## Service Bulletin

Service Bulletin No. / Date: TM TAE 125-0001, Revision 25 / April 22, 2026

**Subject:** Time Between Replacement (TBR) and Time Between Overhaul (TBO)

**Type affected:** Entire aircraft engine TAE 125-01, TAE 125-02-99, TAE 125-02-114, TAE 125-02-125

Fig. 1 Engine Version Identification

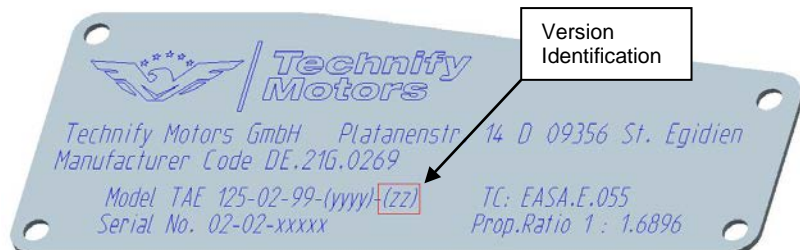
### Identification of Engine Version on Type Plate:
